DEVELOPMENT REVIEW COMMITTEE (DRC) COMMENT REPORT

PROJECT NAME: Bayview Mixed Use Project

CASE NUMBER: UDP-S22045

REQUEST: Site Plan Level III Review: Conditional Use for Mixed Use Development and Allocation of Units for 180 Multifamily Residential Units and 11,500 Square-Feet of Commercial Use

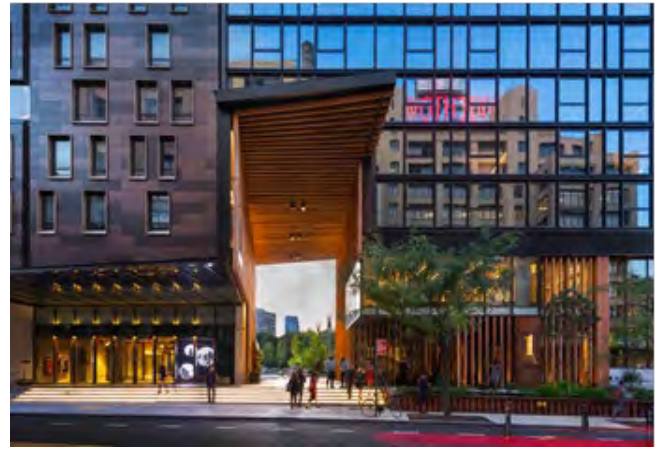
- iv) Provide bicycle parking ratio used for project.
 - d. The commercial space should wrap around the building to further activate the southwest corner and better connect to the proposed plaza.
